**MUDDY RUN II STREAM AND WETLAND RESTORATION
PROJECT
MONITORING REPORT
MONITORING YEAR 7
FINAL**

DUPLIN COUNTY, NORTH CAROLINA
DMS CONTRACT No. 004631 – DMS PROJECT No. 95354
SAW-2011-02191
DWR 2013-0653

RE: Muddy Run II Stream and Wetland Restoration Site: MY7 Monitoring Report
(NCDMS ID 95354)

Listed below are comments provided by DMS on December 17, 2020 regarding the Muddy Run II Stream and Wetland Restoration Site: Year 7 Monitoring Report and RES' responses.

Figure 3a-b. Current Conditions Plan View Map (CCPV)
Table 5. Visual Stream Morphology Stability Assessment
Table 6 Vegetation Condition Assessment
Table 7. Stream Problem Areas
Table 8. Vegetation Problem Areas
Figure 4. Vegetation Photos
Figure 5. Stream and Vegetation Problem Photos

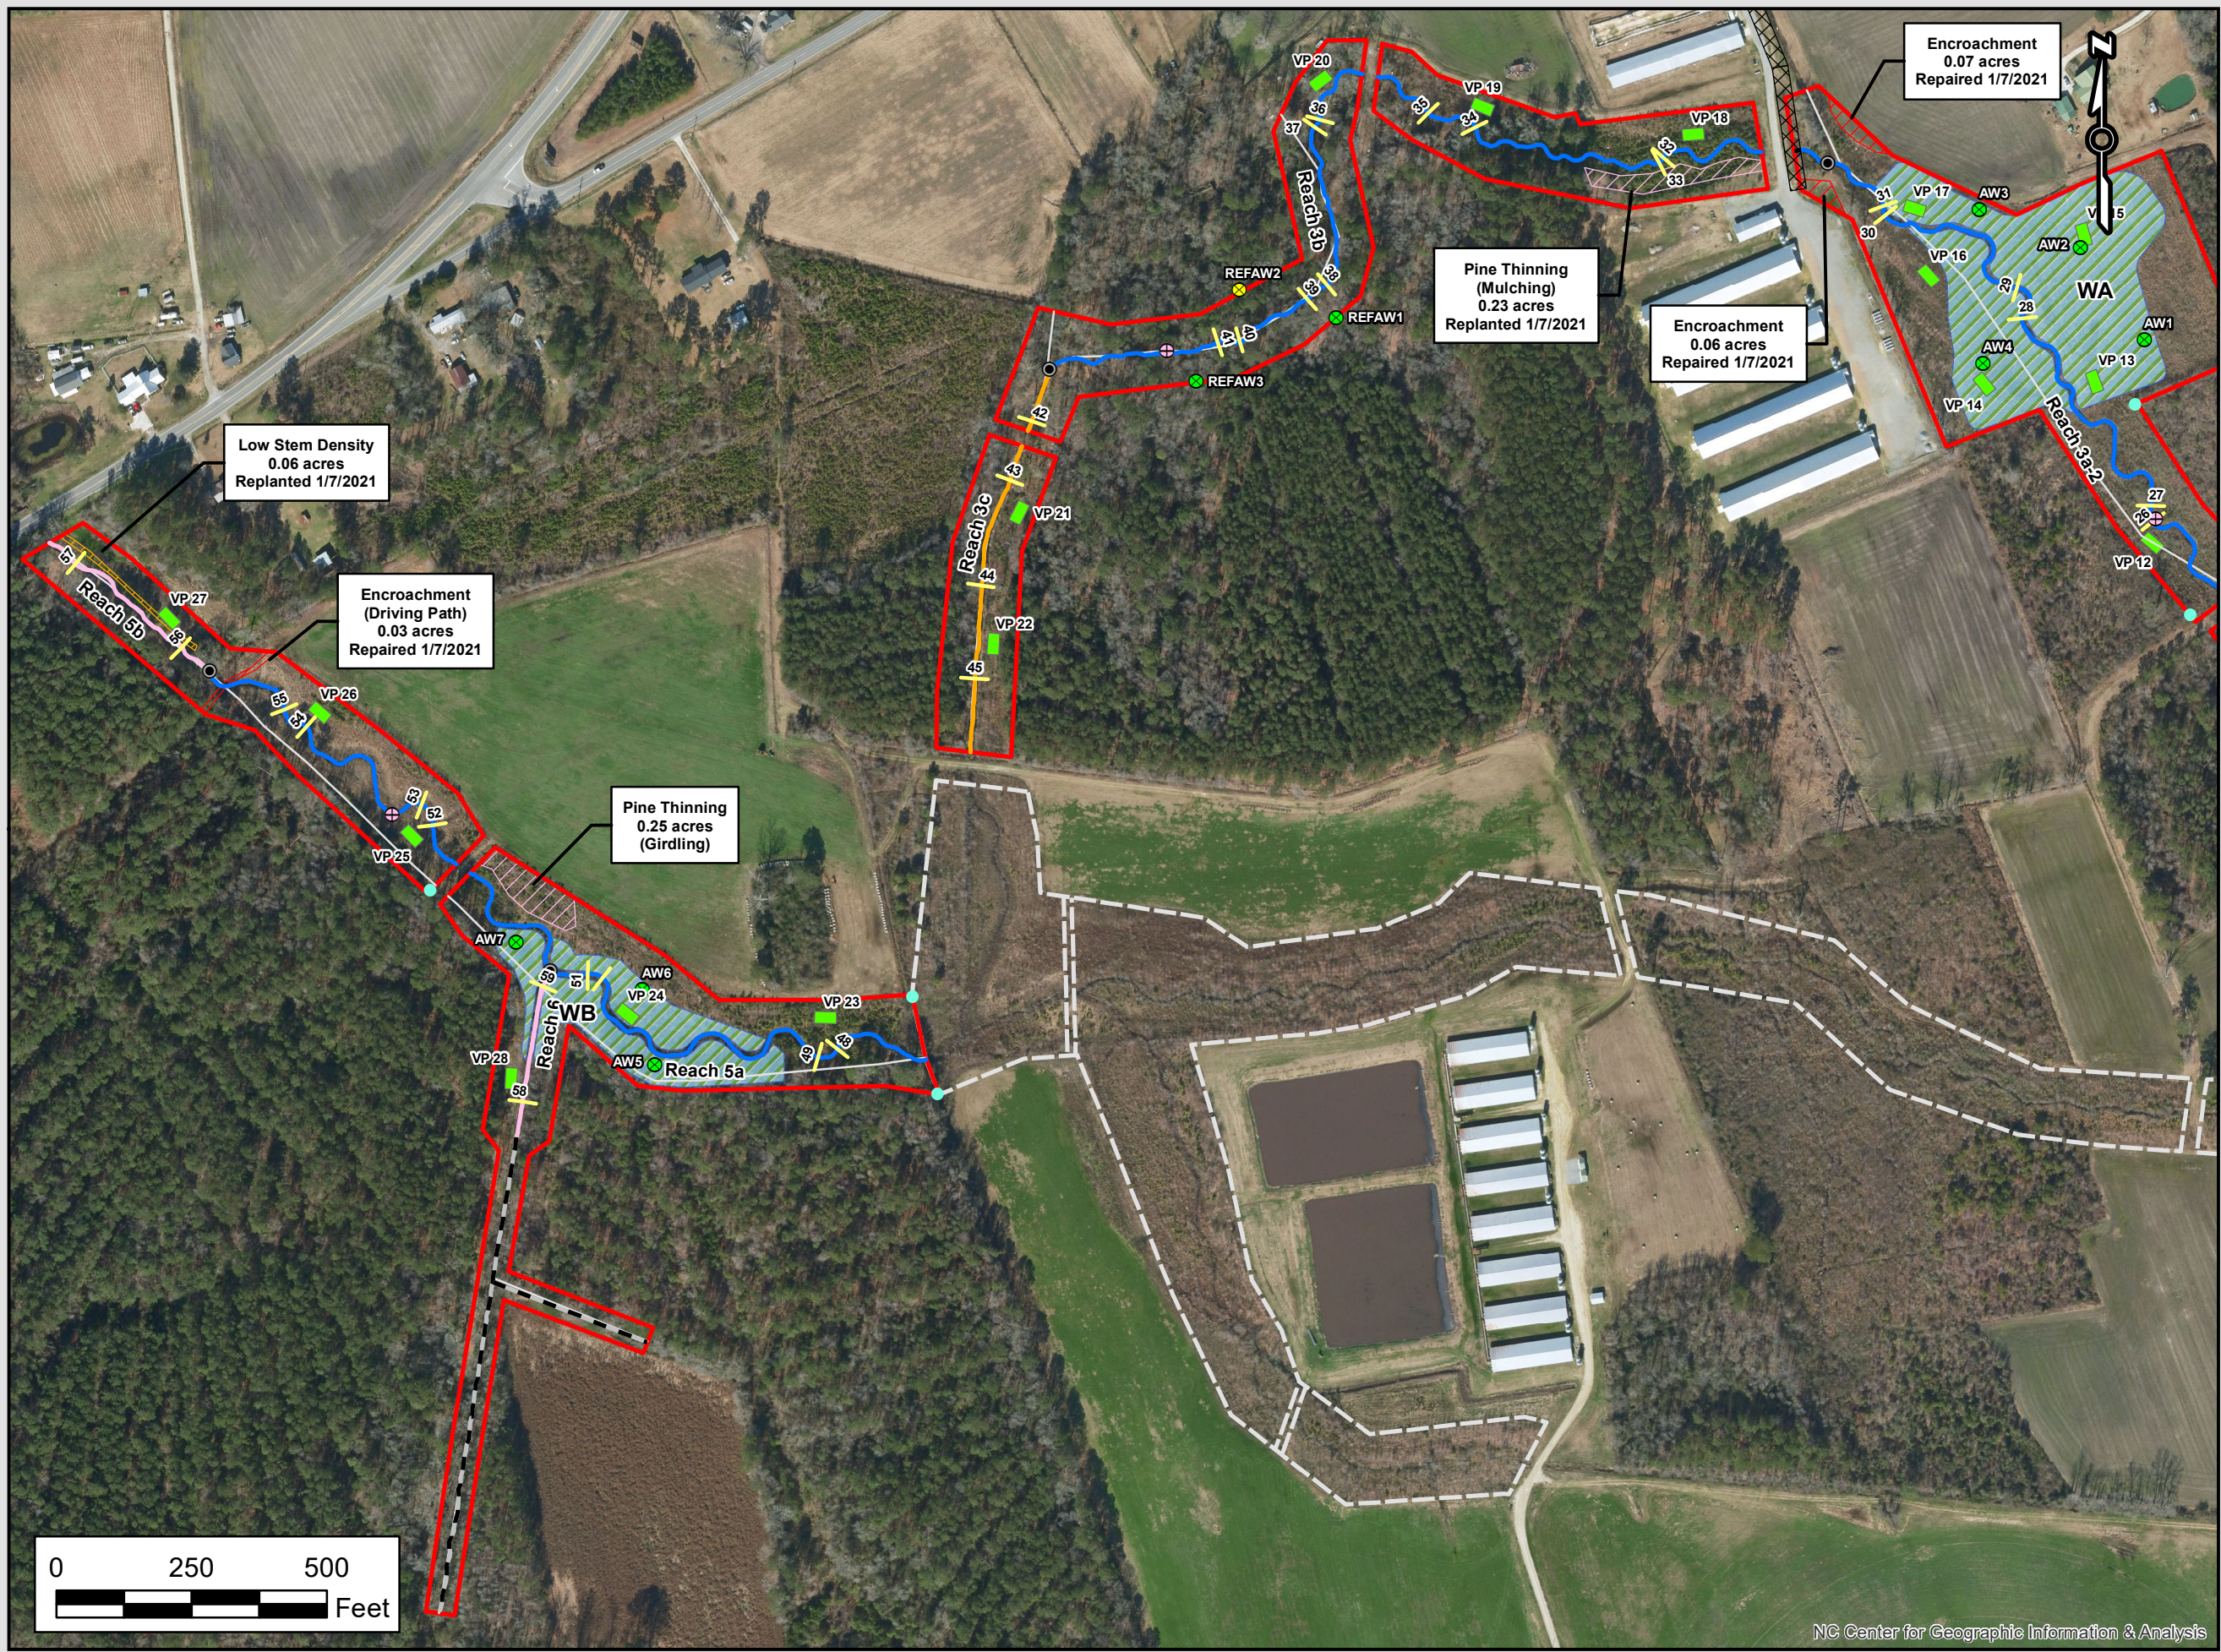
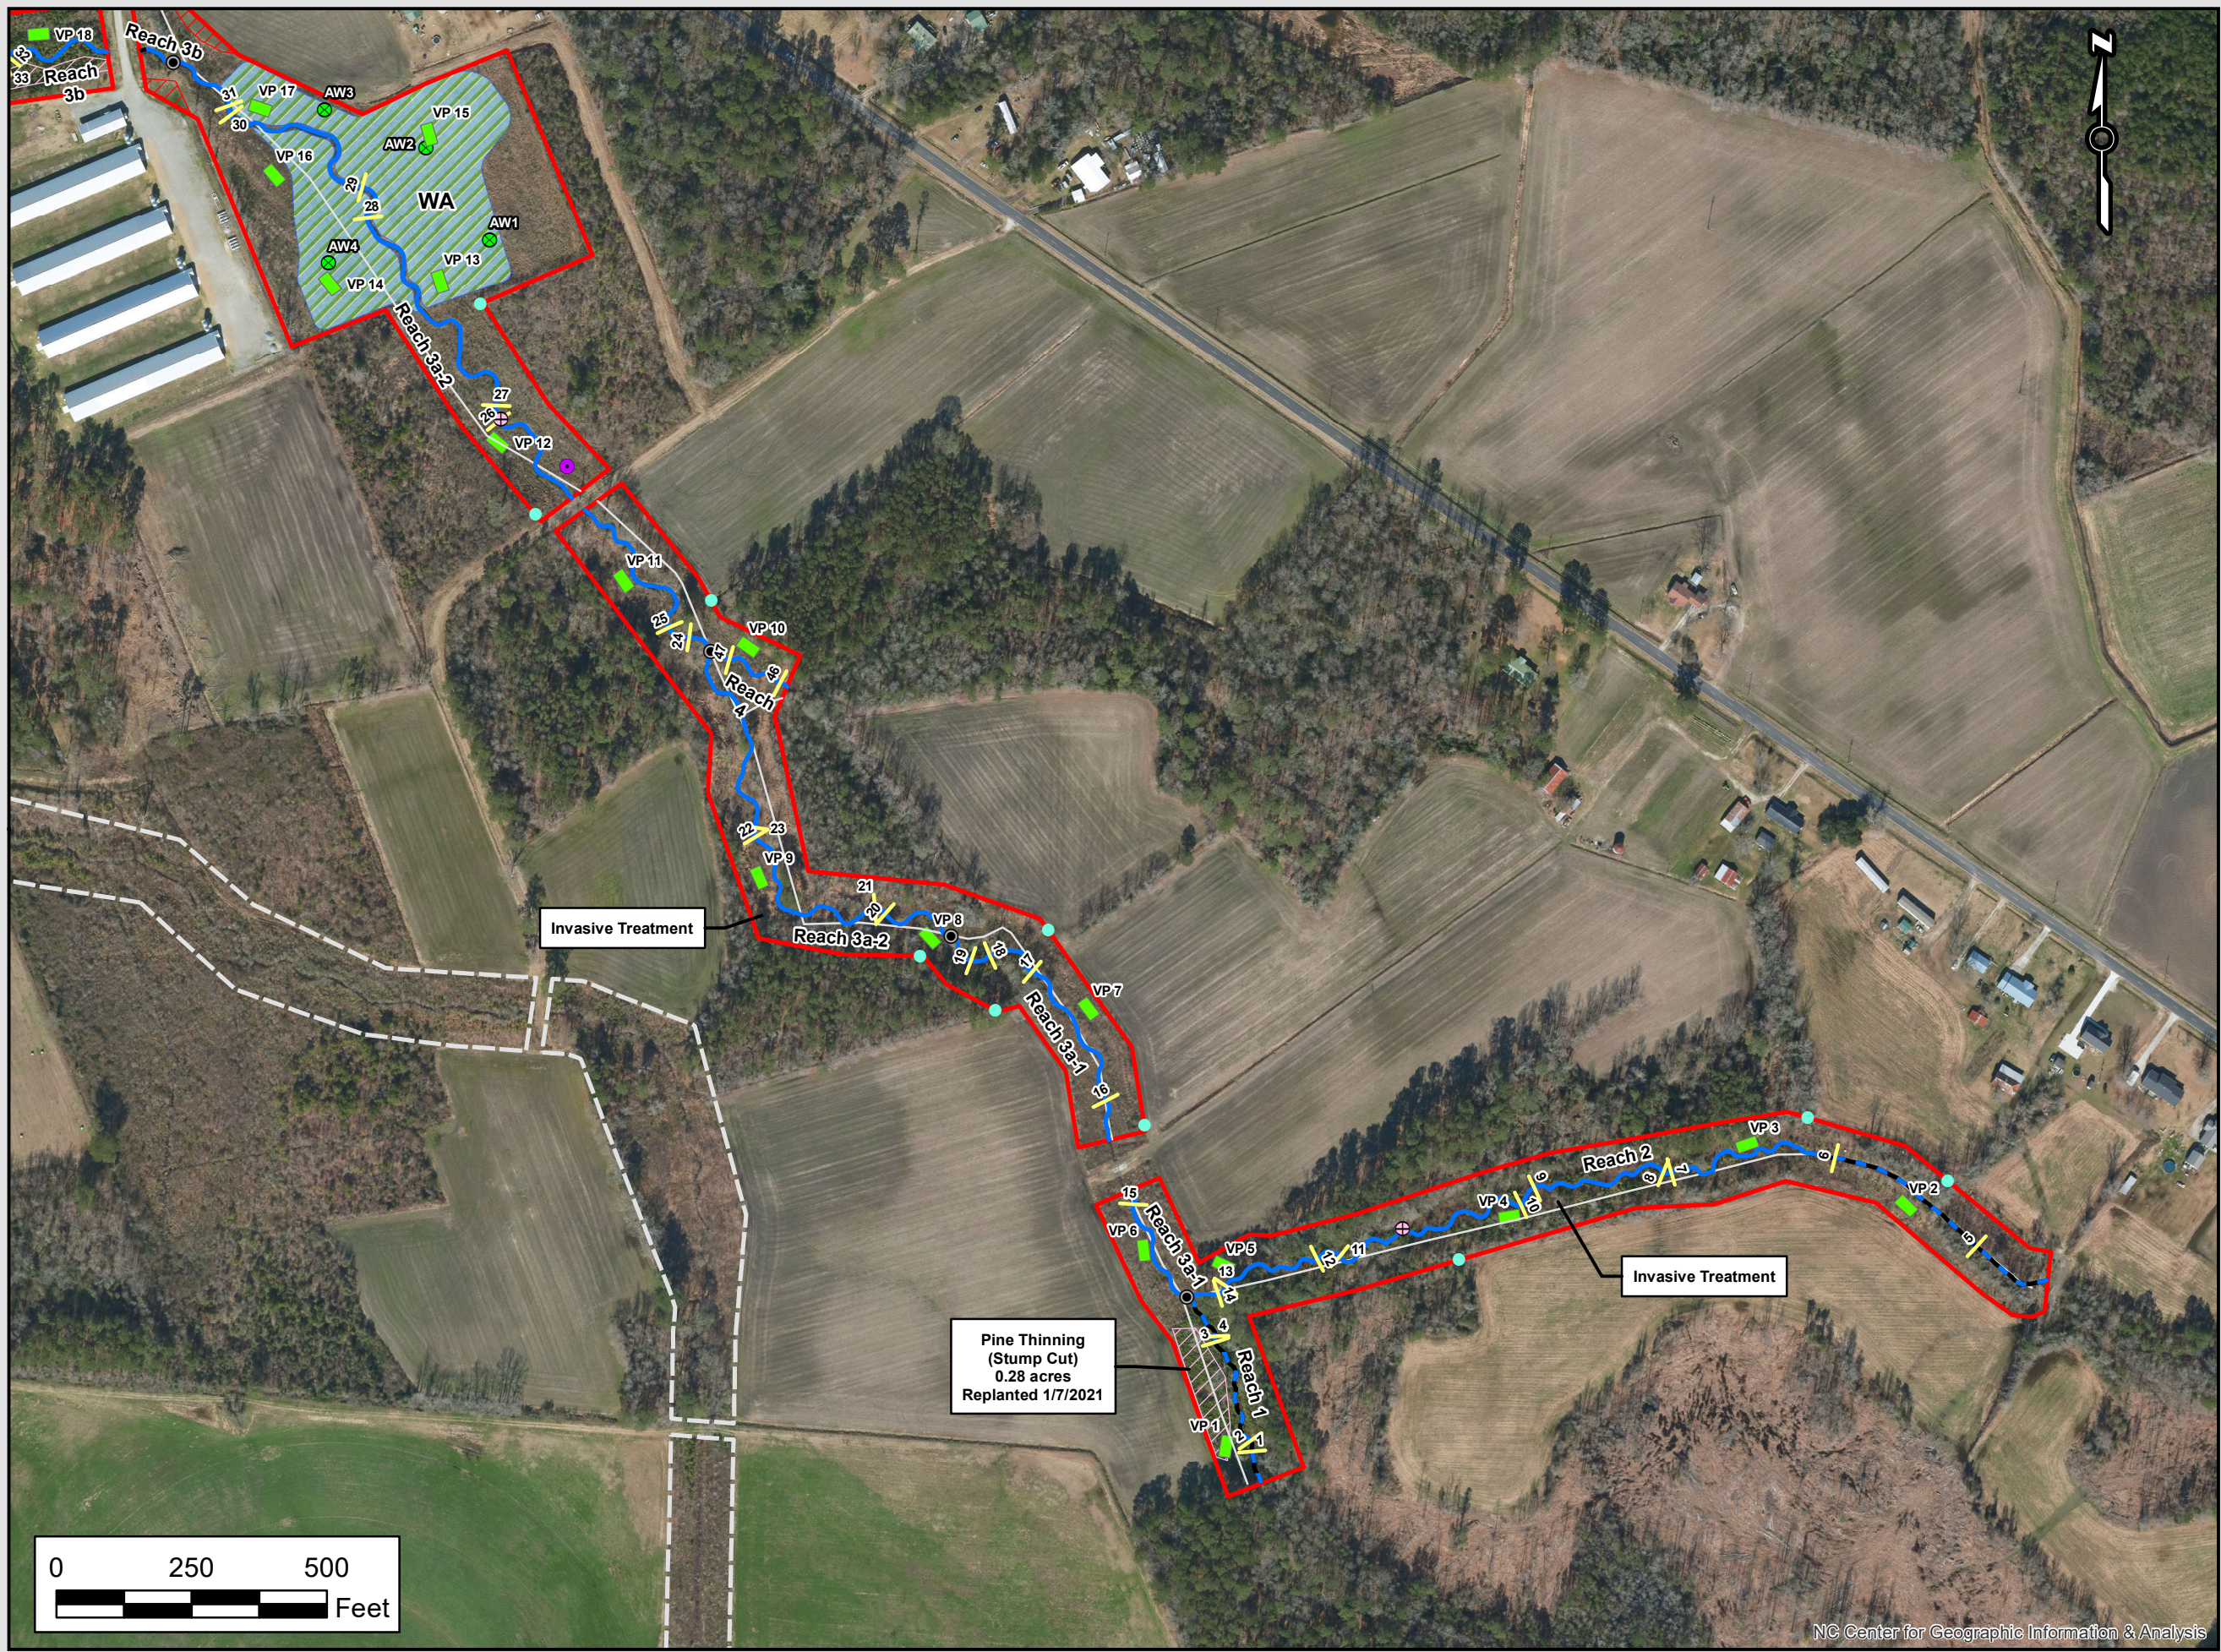
3. CCPV: Please separate the pine thinning shapefile from the encroachment shapefile with different colors and show the extent of both areas (in acres). Confirm if / when both were planted.
Done.

4. Add the overhead ROW on reach 3b near the turkey houses to the CCPV and check that this ROW was removed from credit on the as-built stationing for credit. If it was not considered, determine width of ROW and impact on credit and separate on asset table for removal.

The powerline ROW has been added to the map. The powerline was installed directly along the outside easement edge but due to its 30-foot easement, 13 linear feet of Reach 3b are not creditable. Information about this has been added to Section 1.3.
